HPB23-0575
September 12, 2023

Staff Analysis

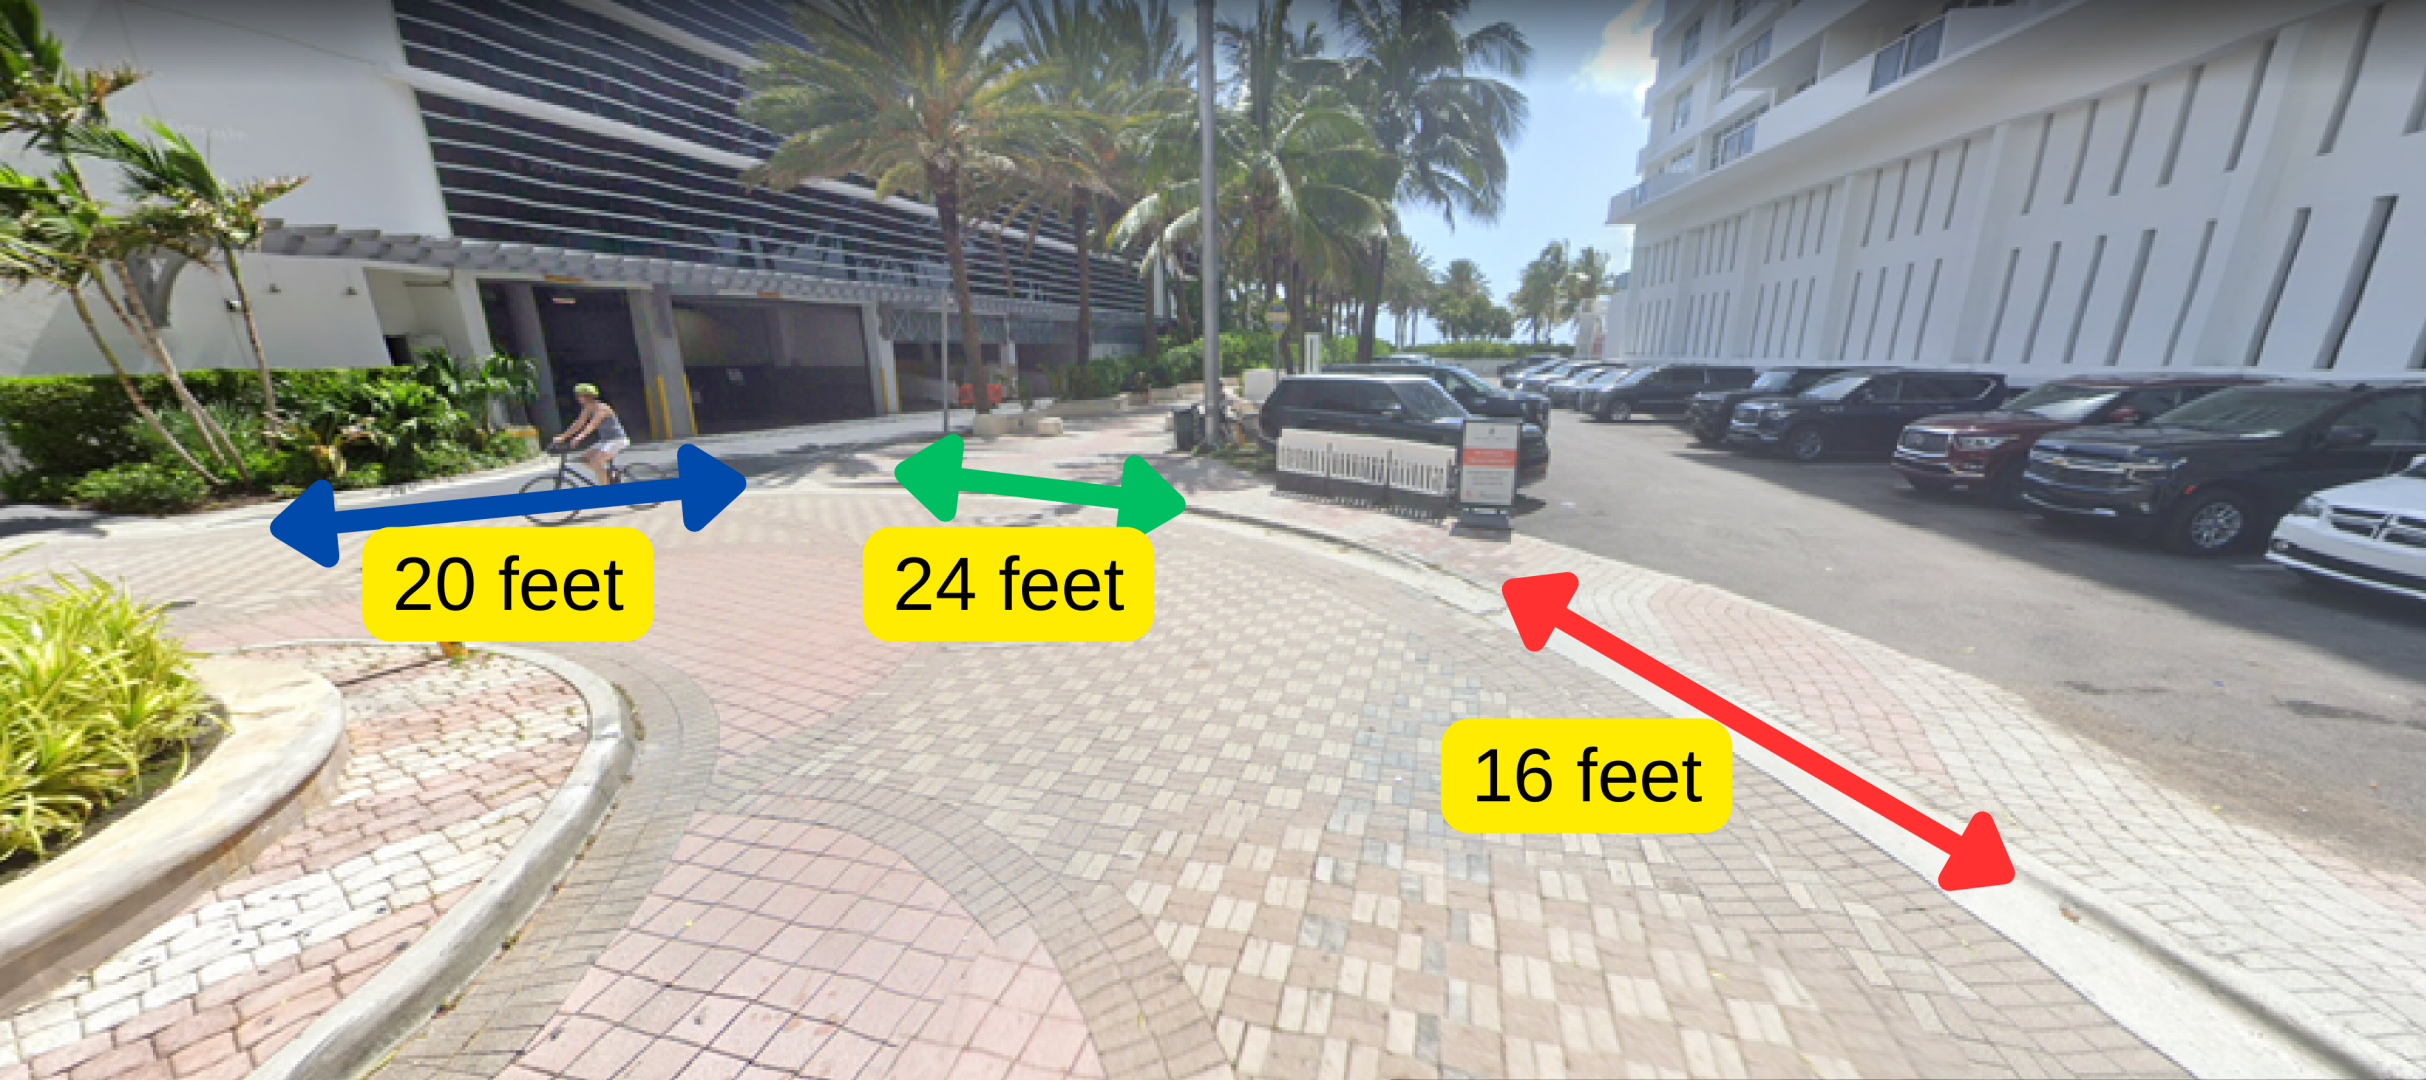
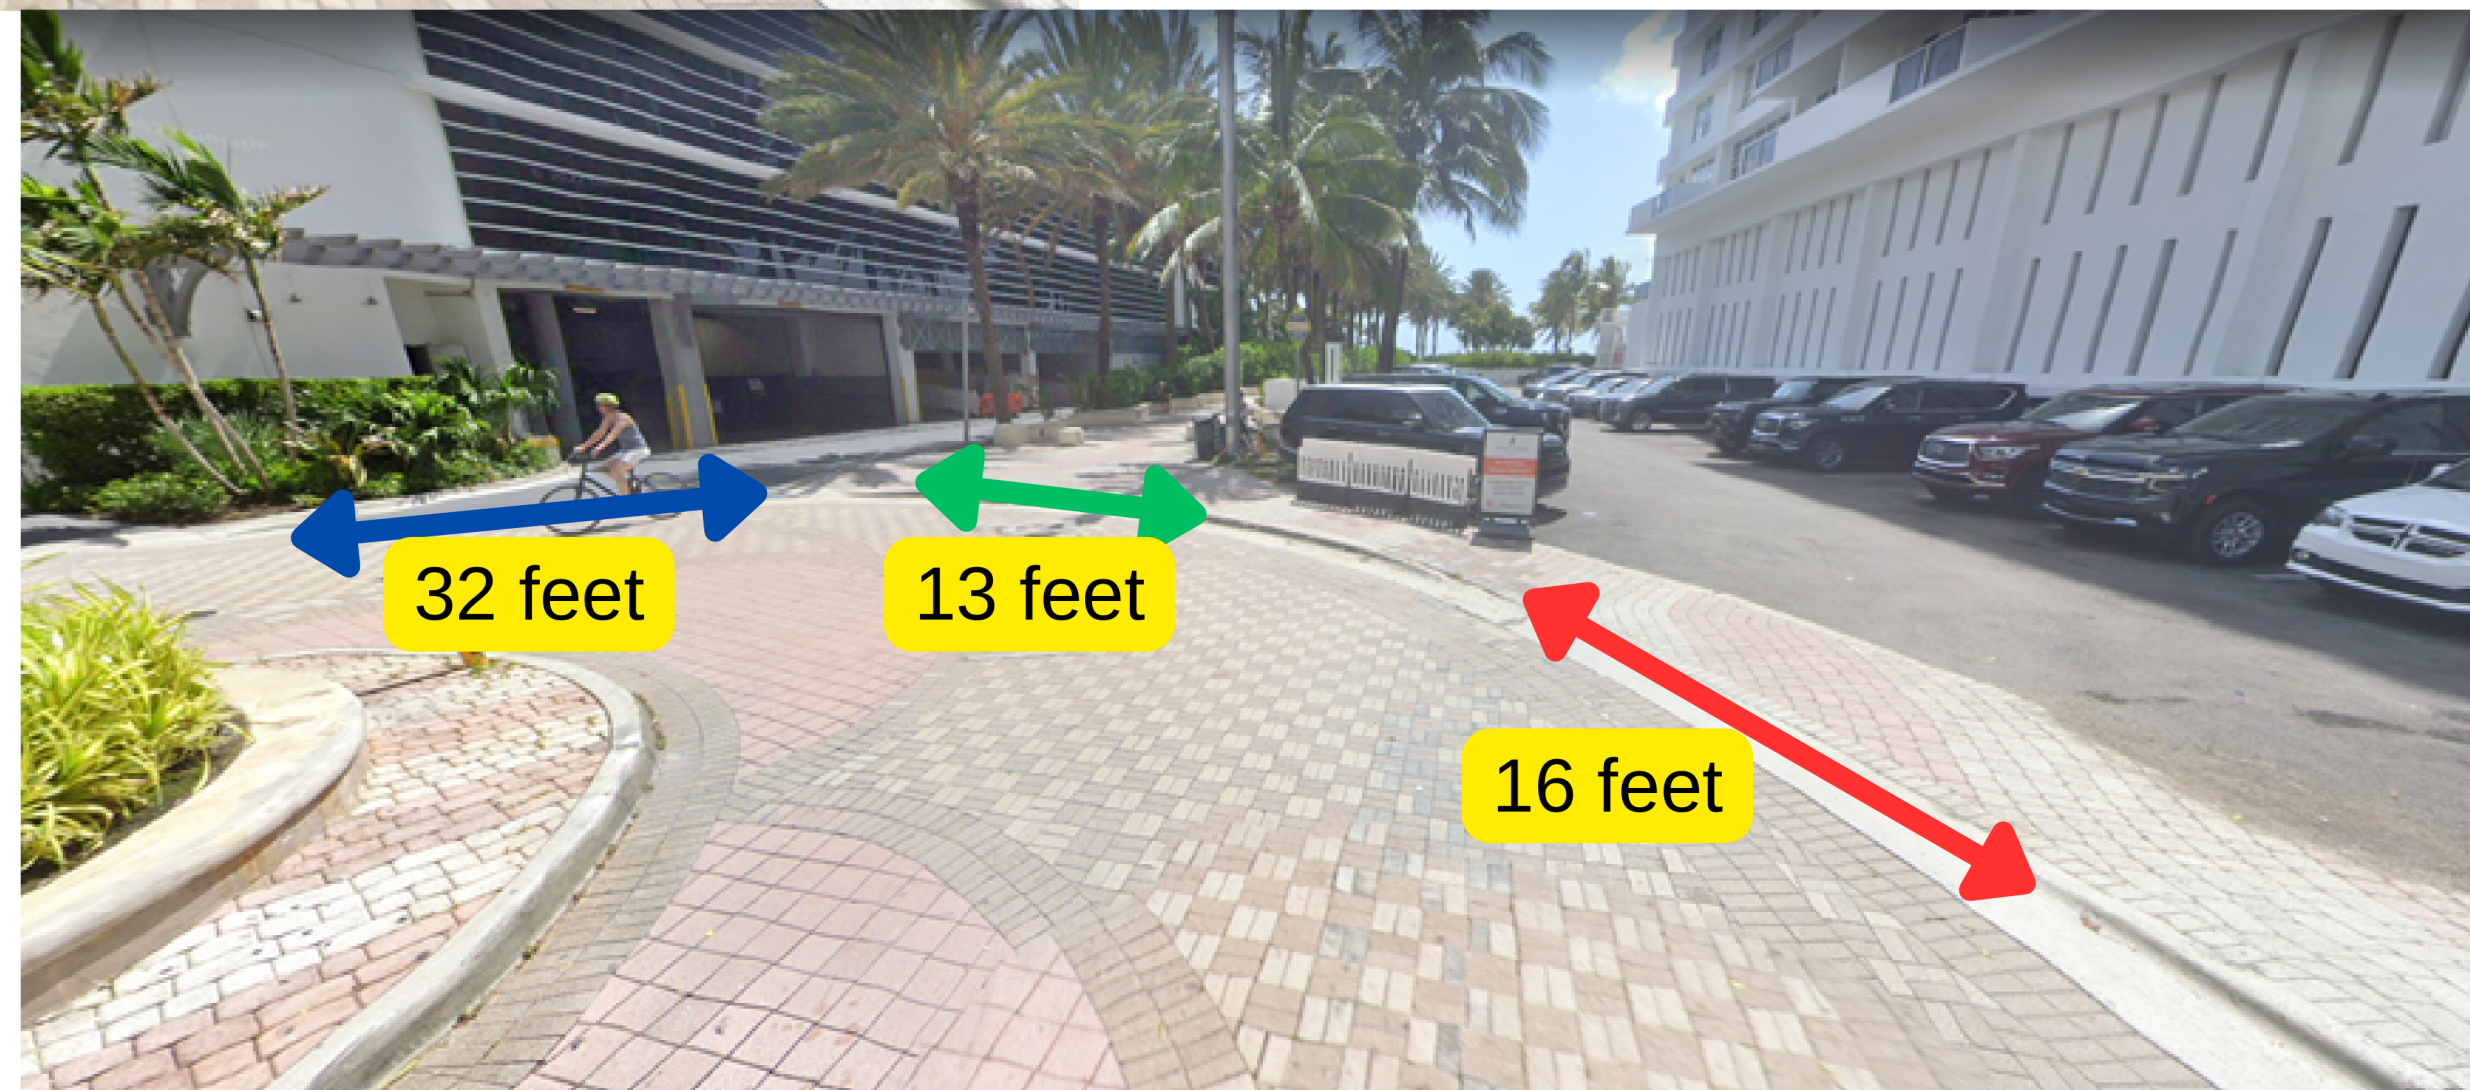
Loading Driveway width increases from 20' to 32'

Beach access path, at street end, decreases from approx. 24' to 13'

Direct applicant to work with stakeholders & staff to refine street-end design to be more appropriate and balanced than proposed

Maneuverability Analysis (SU40)

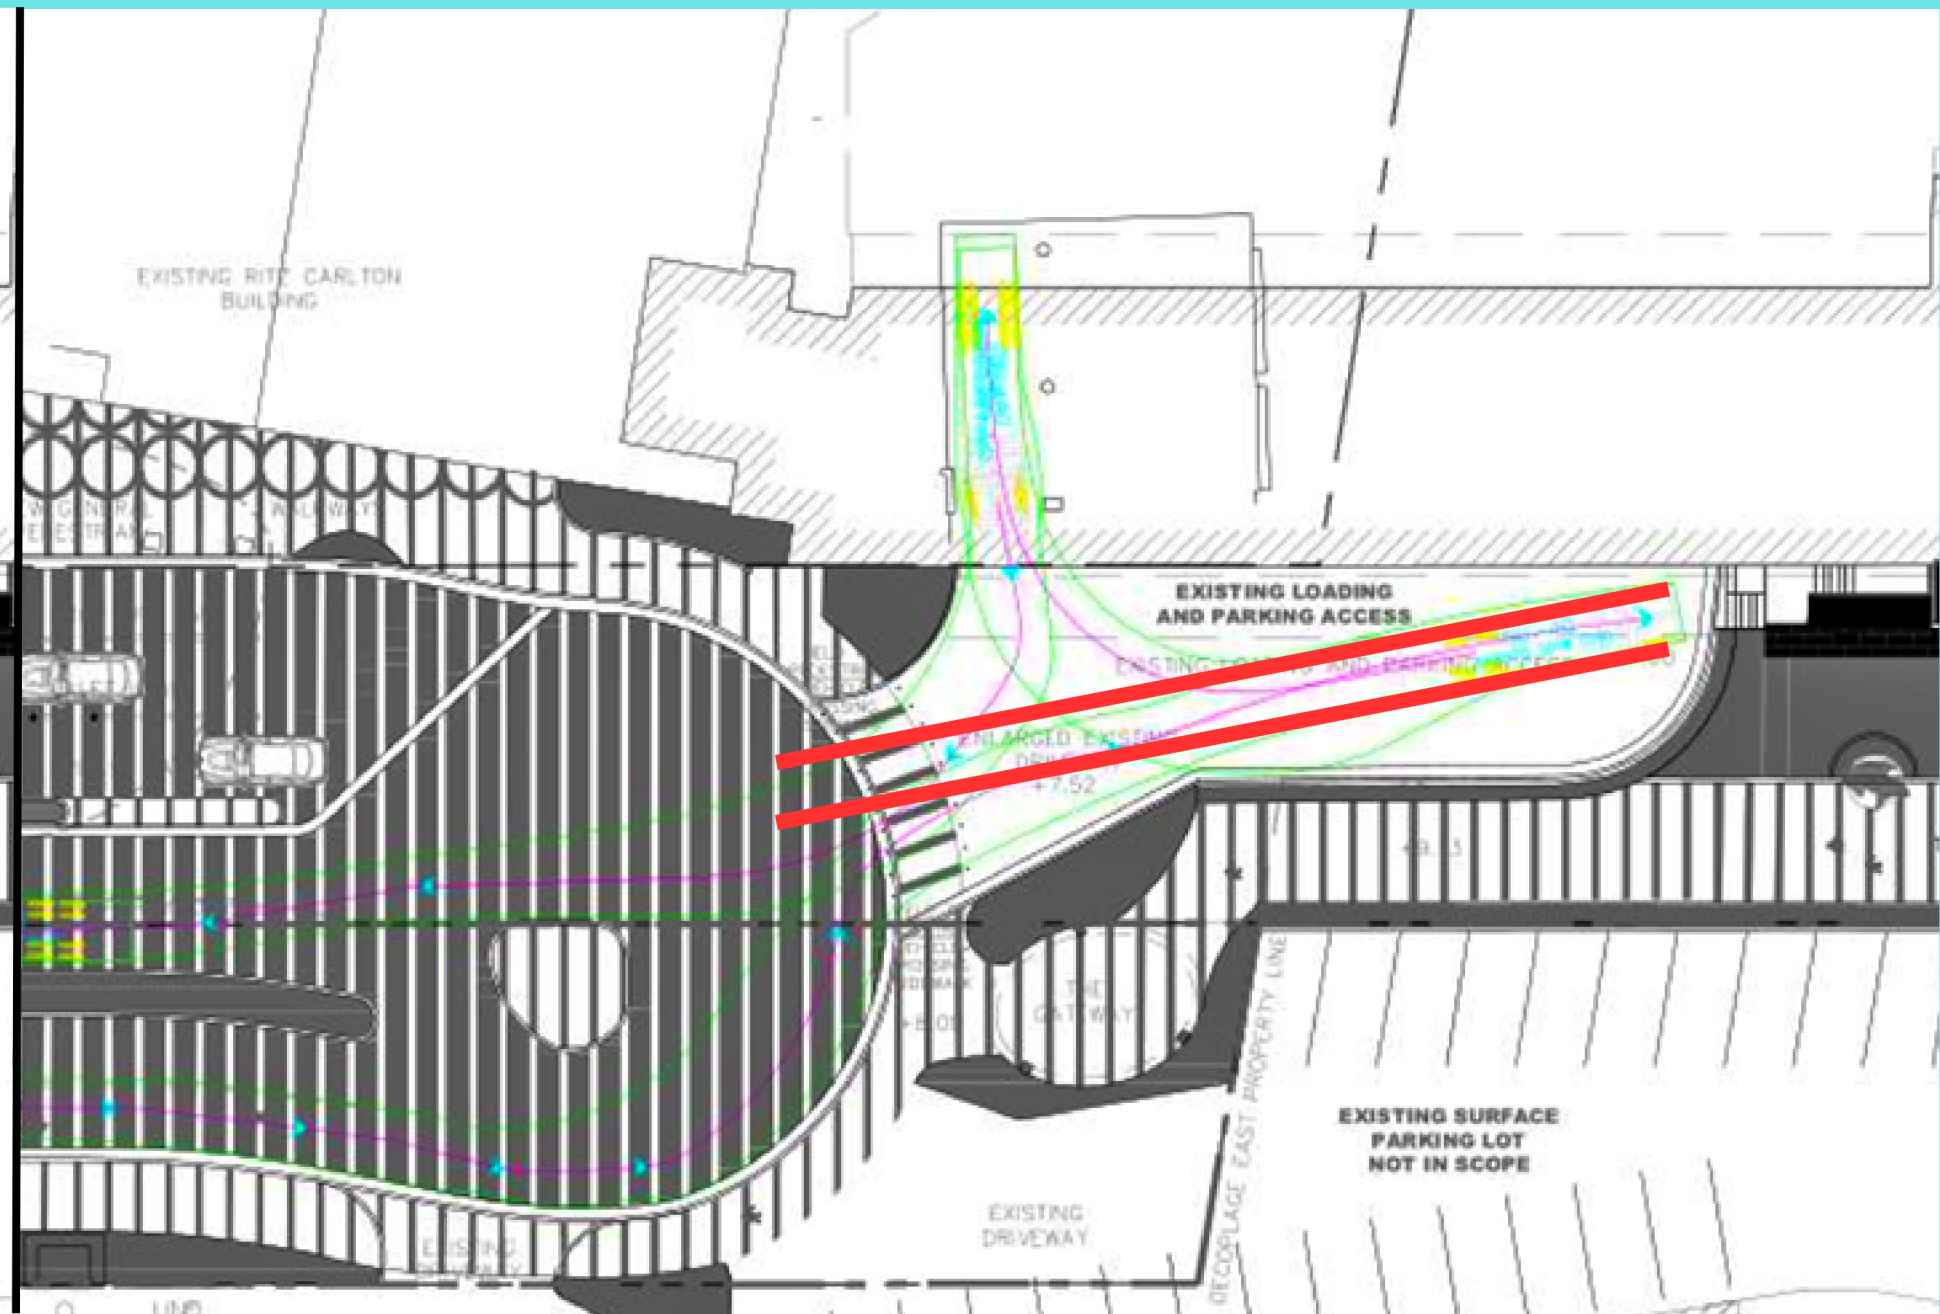
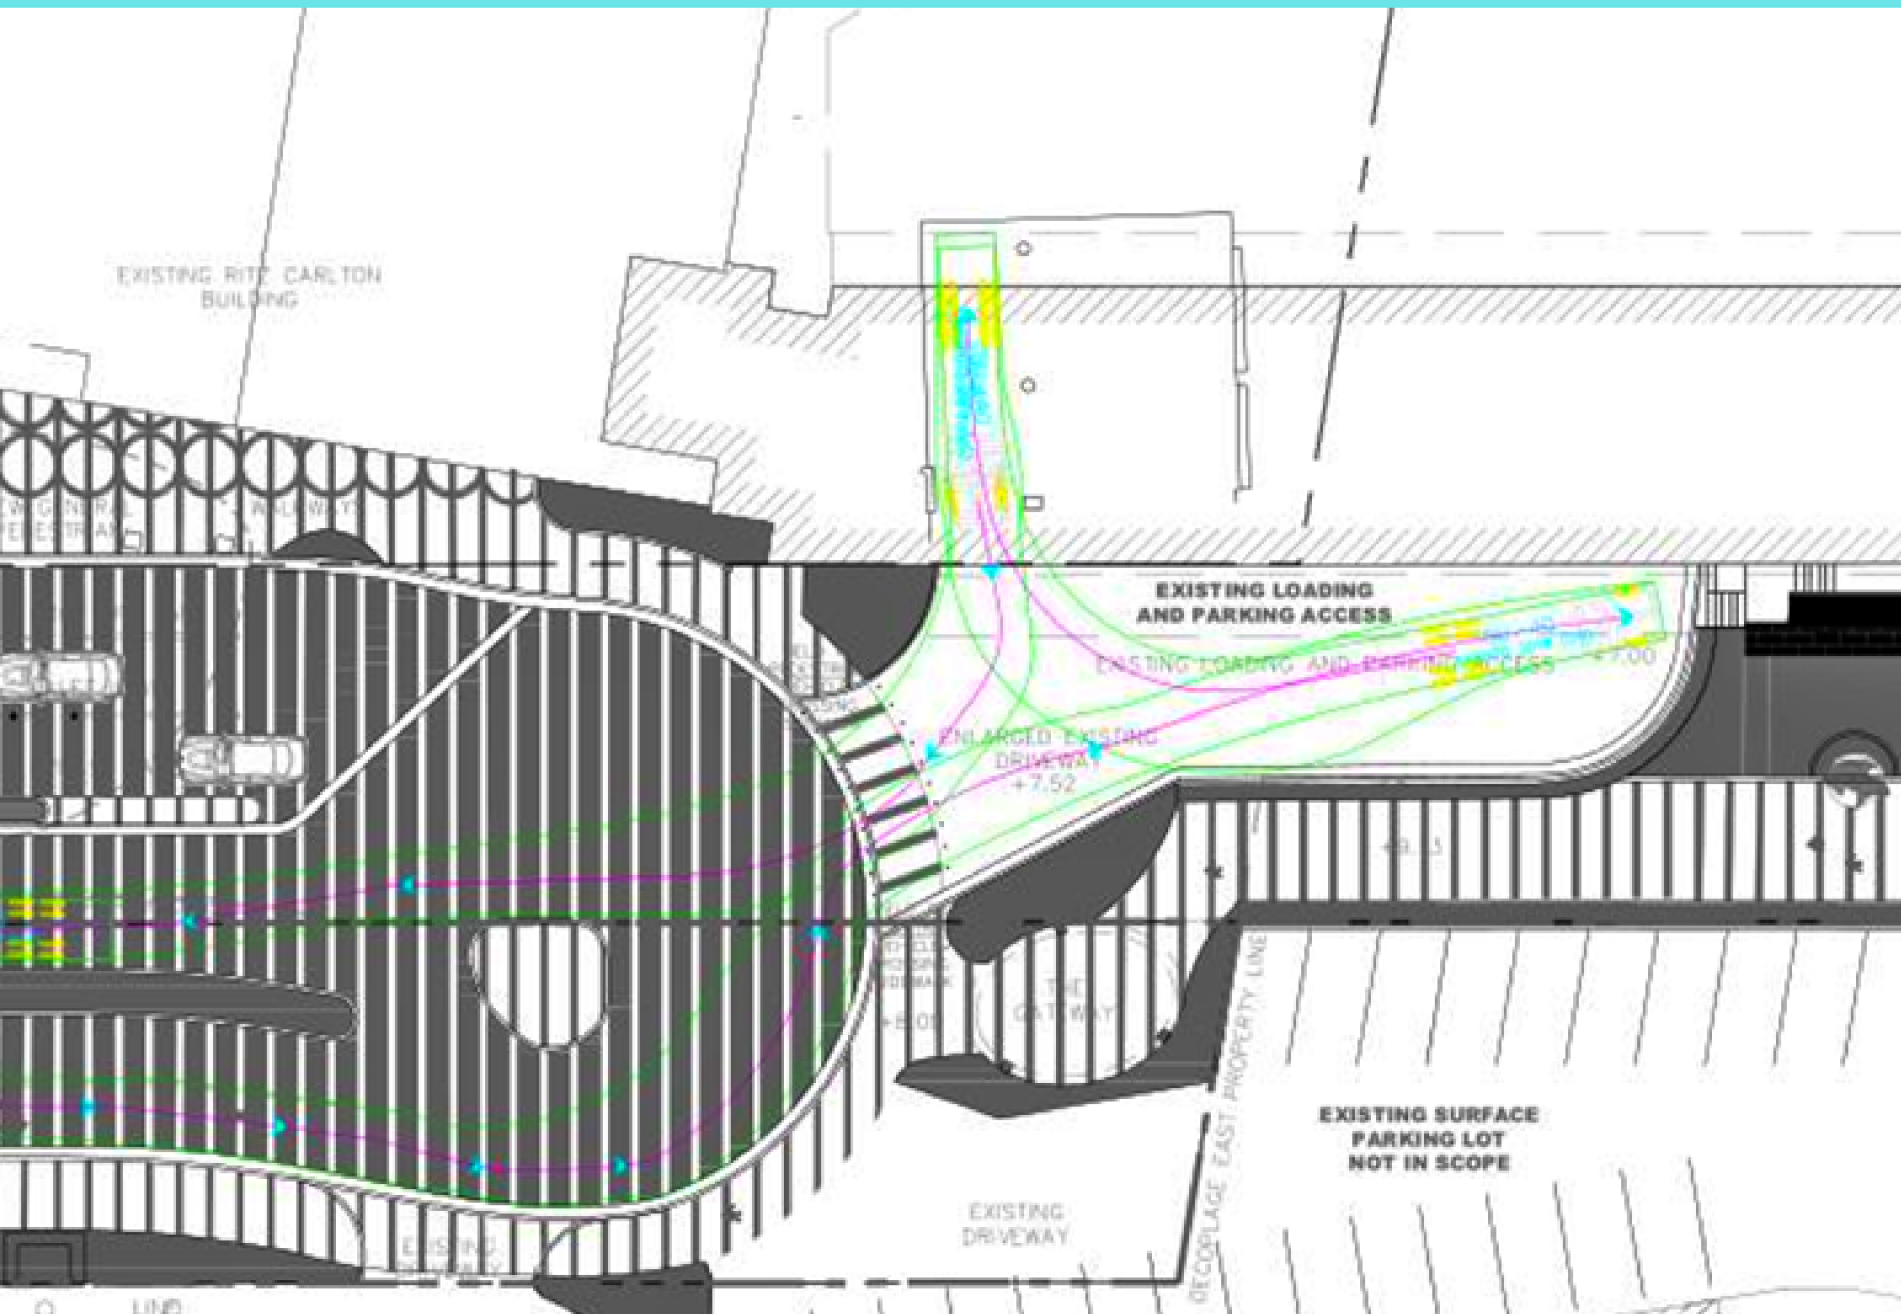
32 Feet (Proposed)

Less Than 32 Feet
(Alternative)
